RE: Request for Quotations 26-RFQ-004 - Etolin Heights Water Heater Replacement - Wrangell

ADDENDUM NO. 3

Figure 2 Tank dimensions: IWT 80, IWT 80-Max, IWT 119, IWT 119 Max

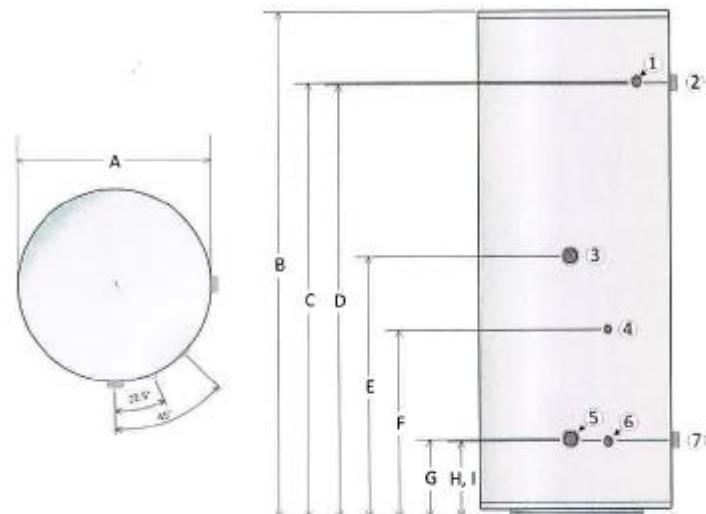
QUESTION 1: The previous addendum seems to incorrectly identify the tank drain as draining the boiler loop to the indirect water heater. The tank drain drains the domestic water from the tank. The domestic water fills the tank and the boiler water enters and exits a coil which heats the domestic water.
See attached diagram from the IBC IWT manual showing a drain on the return portion of the boiler loop to and from the tank. If the tank drain drained the boiler loop this drain would not be necessary and would be shown on the domestic water inlet.

ANSWER: In the attached tank image, the tank drain is correctly identified as Port #6. Ports #5 and #3 are part of the boiler loop, with Port #5 being the low point. Ports #7 and #2 are the domestic water supply connections, with Port #7 serving as the domestic system low point. The IWT-119 MAX provides a dedicated drain port at Port #6, which is acceptable to us. We are fine with this low-point drain location as long as the installed drain is a quarter-turn valve with standard hose threads, not the small 1/4-inch coin-vent style drain that is typically supplied. The intent is to be able to drain the tank efficiently and quickly.
